Quick investigation of BA15 cap-holder systems

Evaluation proposal Valeo (reference TF SR-01-10)

Examination Valeo Proposal:

Proposed **PY21/LED**
bulb holder BAU15*s

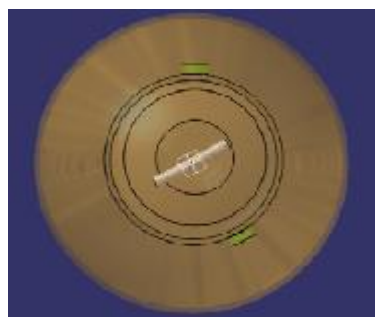
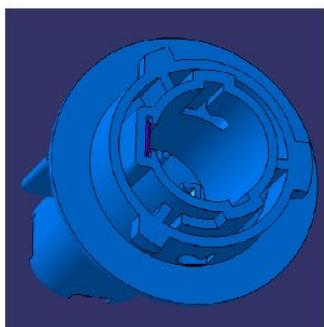
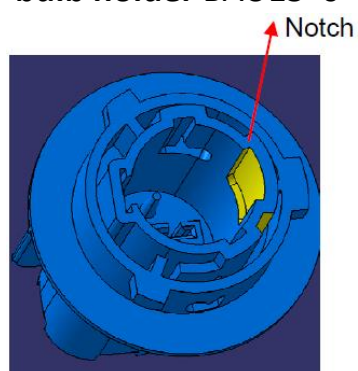
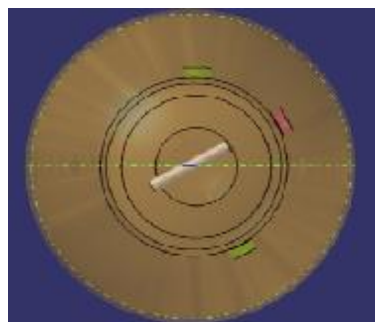
Extending the 3rd pin option for Existing cap BAW15d/s in a similar direction as proposed doe the BAU15s cap result in two options:

3rd pin for also for BAU15, and BAW 15?

BAU15*d/s

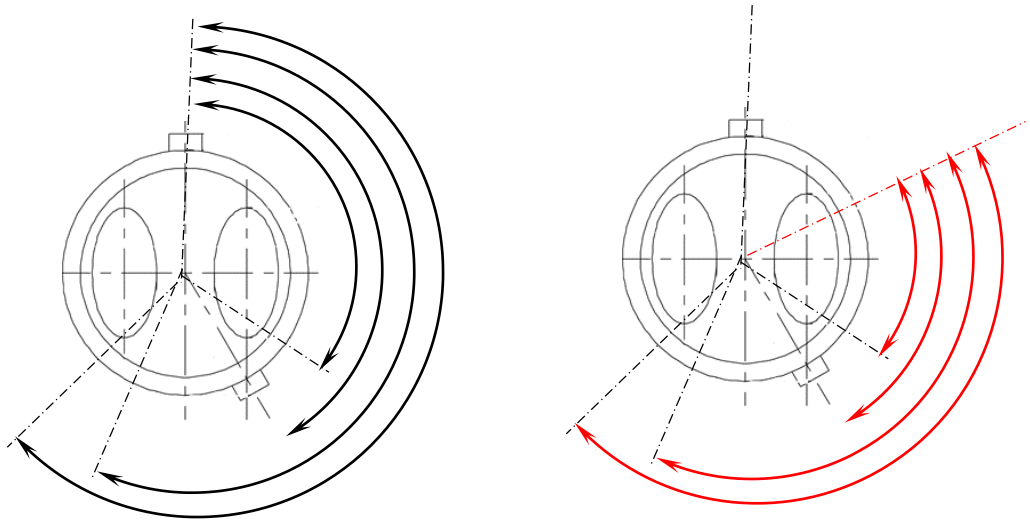
- Angular offset from Reference pin (estimated from input):
 - A slot at +70°, 80°, 90° 100° or 110° clockwise holder top-view (see next slide)
- All* current Automotive 15 mm Bayonet fits with this 3rd pin added,
- All* “Non-LED” automotive fit-types to be checked:
 - “reference” Cap-pin in “new Holder-Slot”
 - “non-reference” Cap-pin in “new Holder-Slot”
 - Some fits use a different “height” for the 2nd pin than the reference pin.
- Some executions appeared **close fit (see following pages),**
(tolerances are expected not to prevent a Non-intended-Fit)
- Basic difference in “angular step” for the pins in this system should be 20° to enable a clear discrimination in the system

* the BAX system is not taken into account for it's different pin lengths is not a real discriminator in the BA15; it just fit's and there is no adequate holder definition in IEC

- Discrimination to existing systems >10° (20° preferred to cover tolerances and effective discrimination)

→ From 100° to 110° a solution seems possible.

Check: BA15-LED-Holder \forall_s non-LED caps

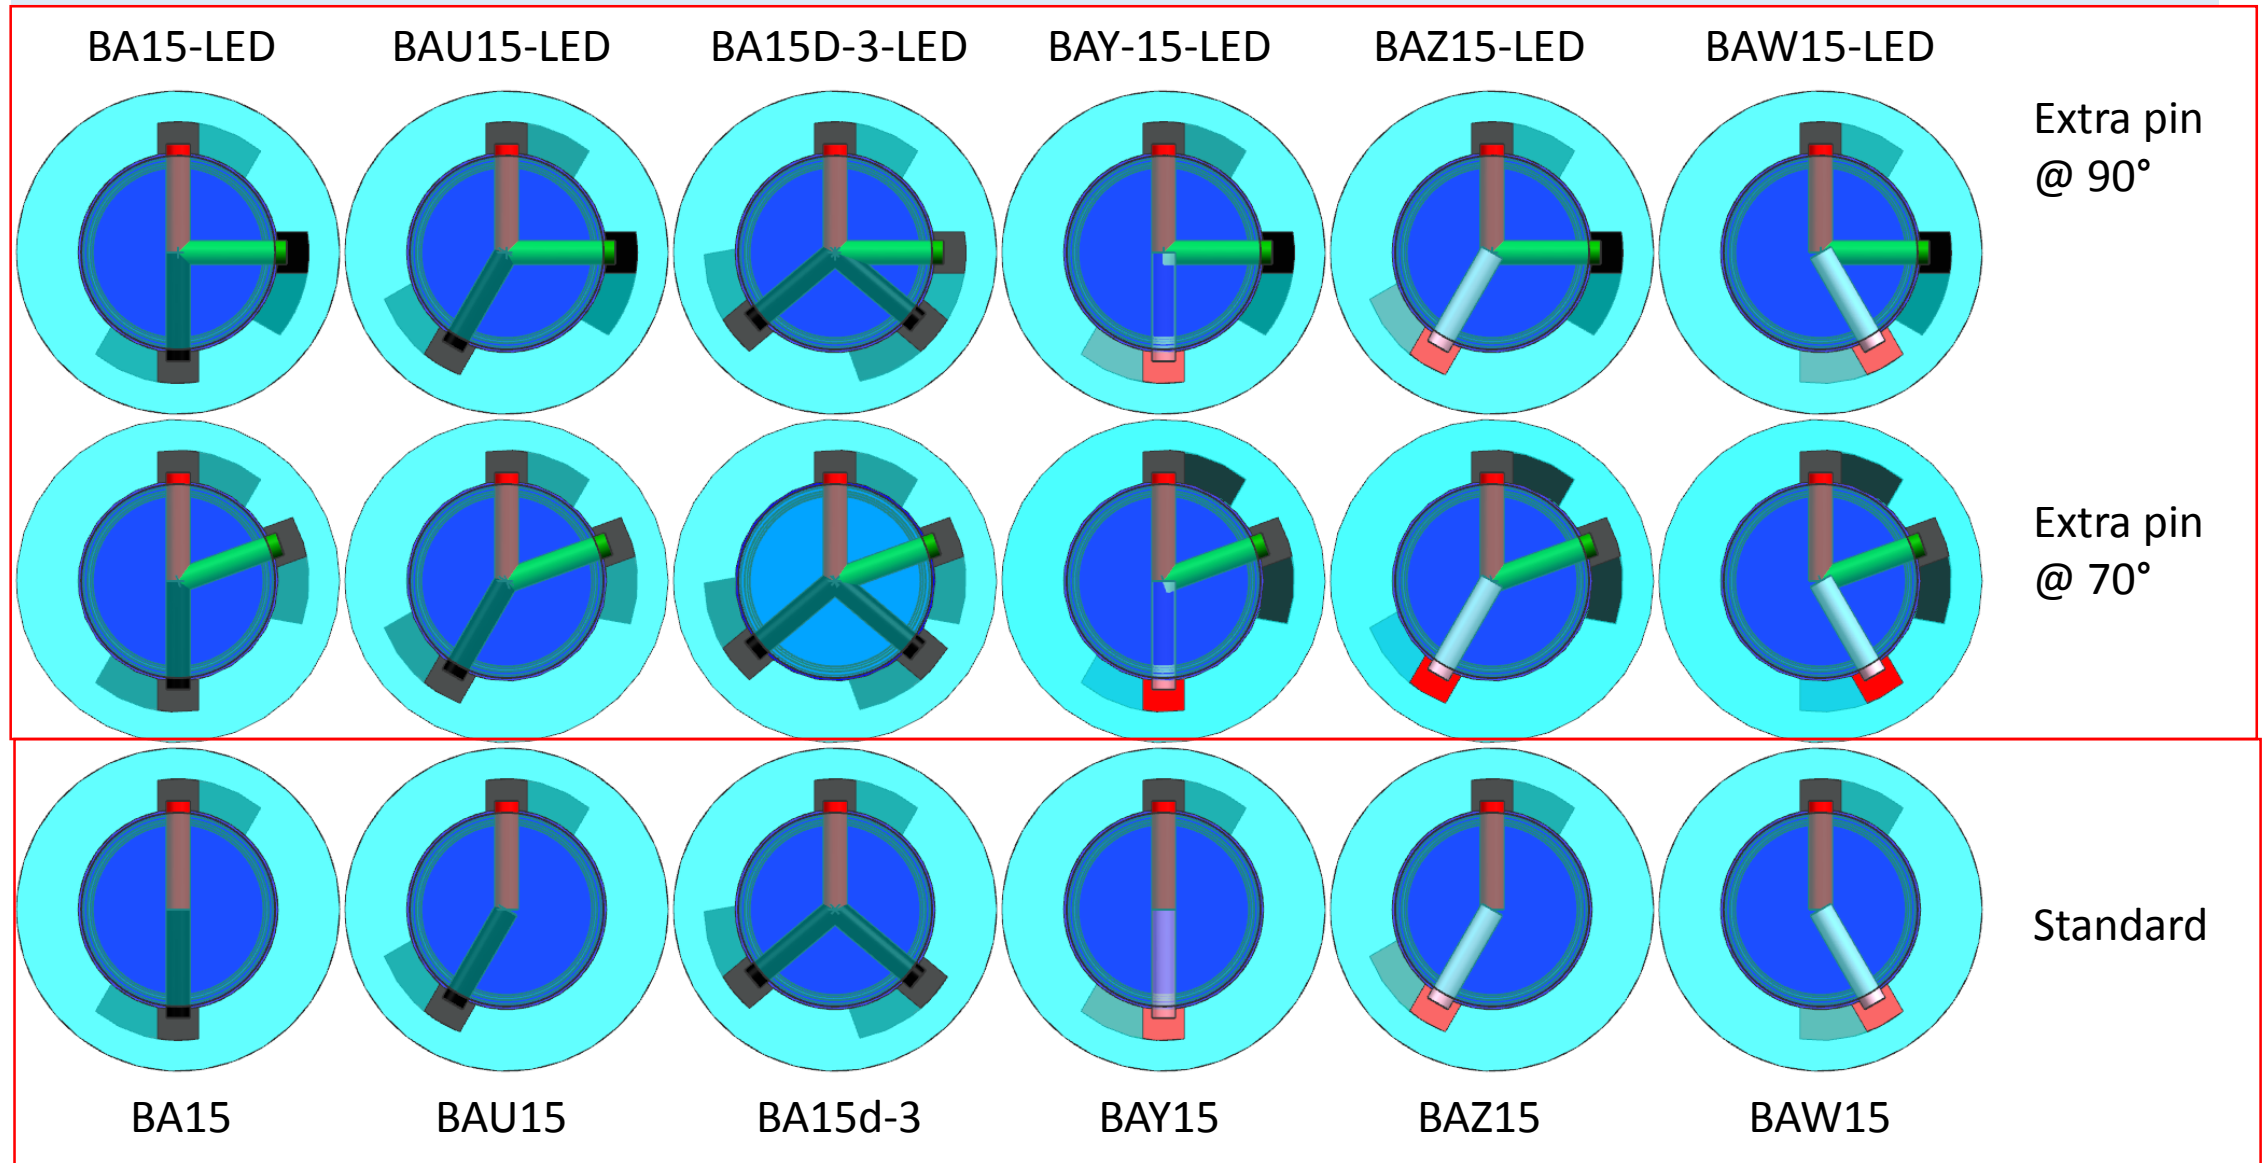
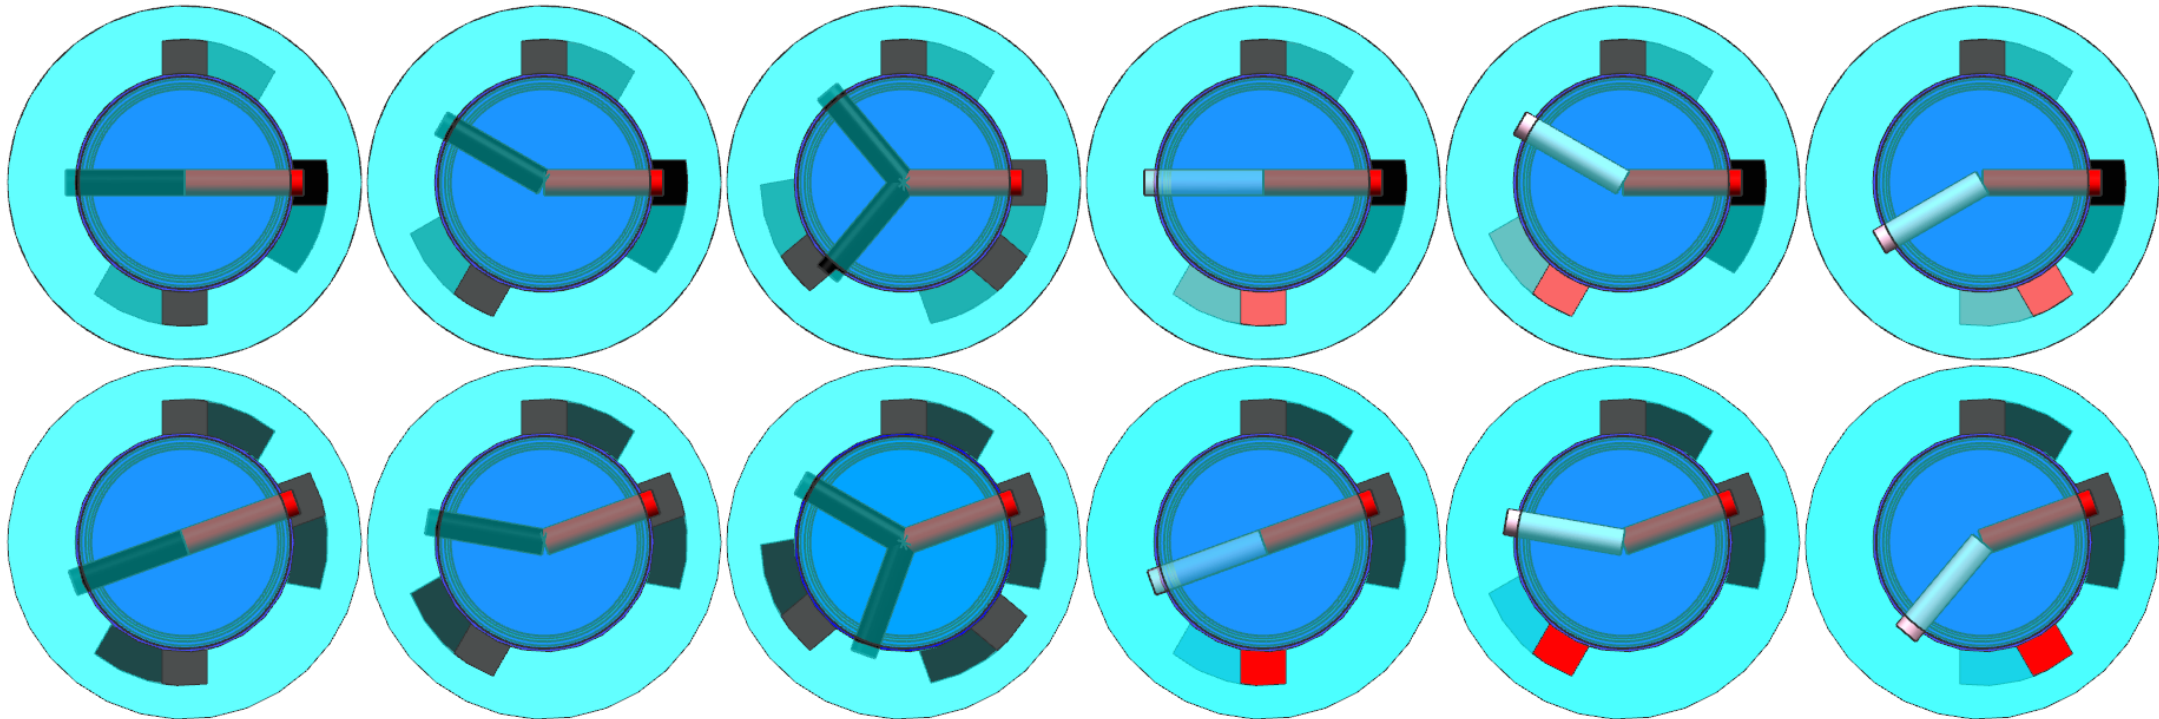
70° and 90° versions (based on Valeo proposal)

Extra pin
@ 90°

Extra pin
@ 70°

Check: BAU15-LED Holder- \forall_s non-LED caps

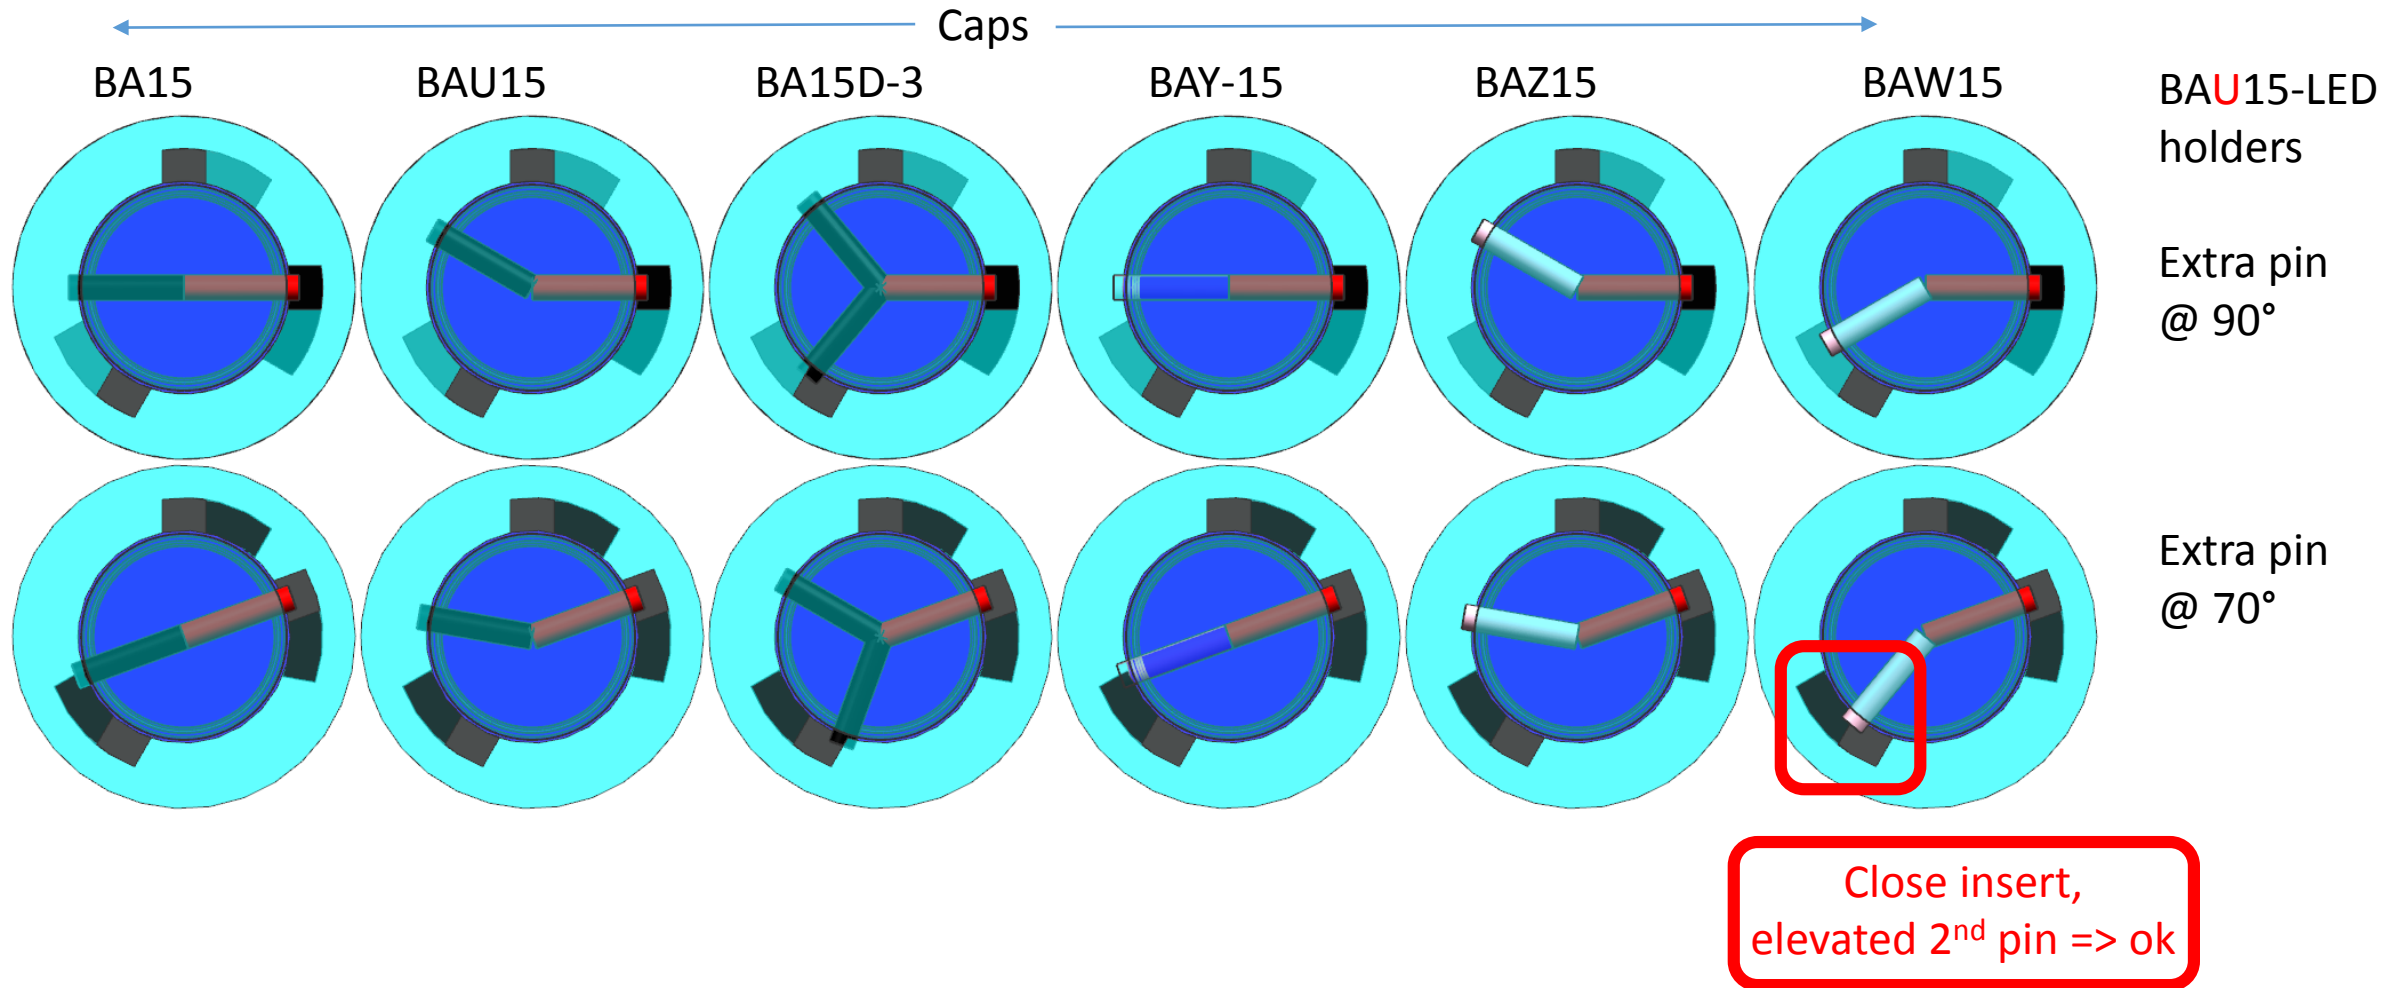
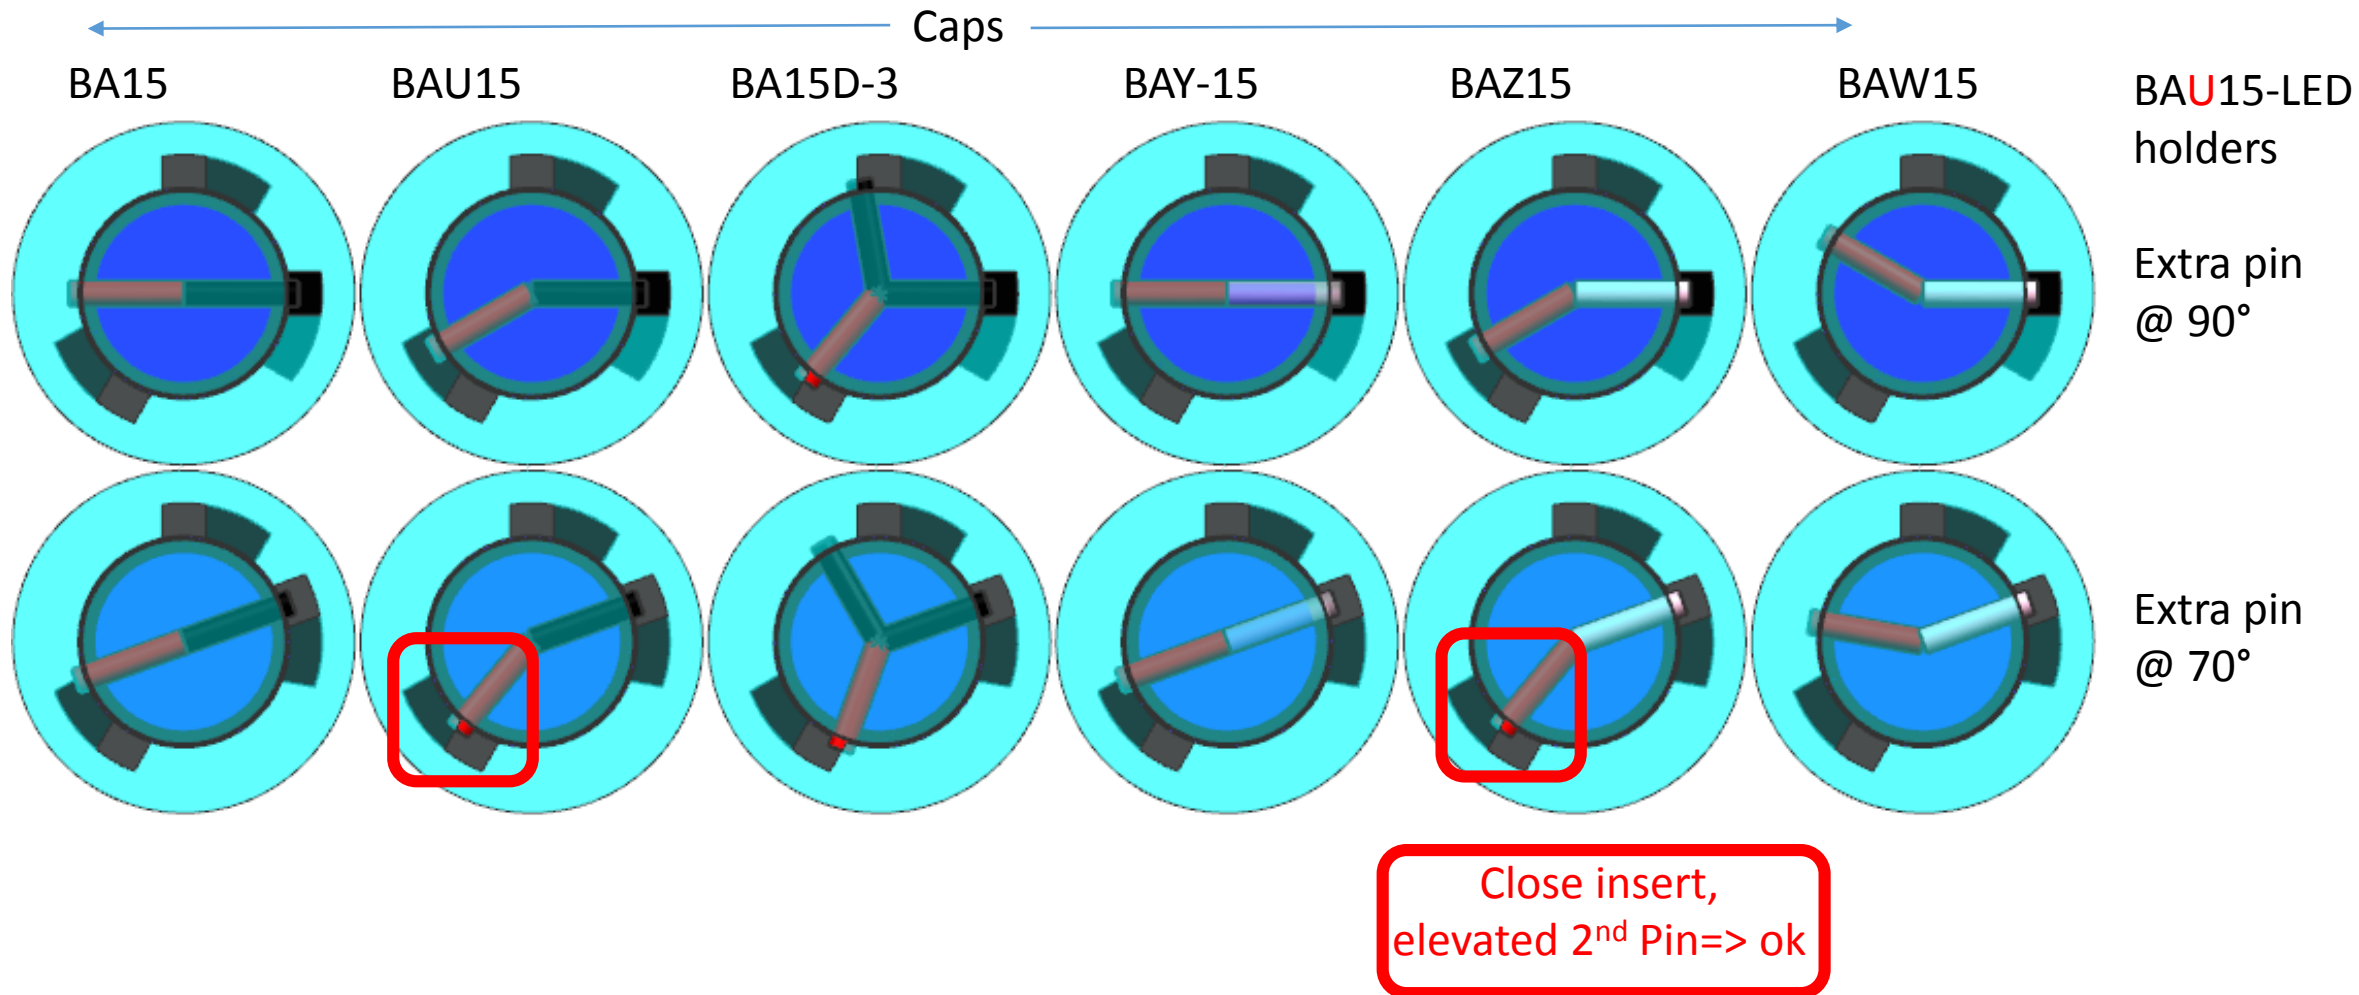
Ref pin in new slot

Check: BAU15-LED Holder-^{v/s} non-LED caps Non-Ref pin in new slot
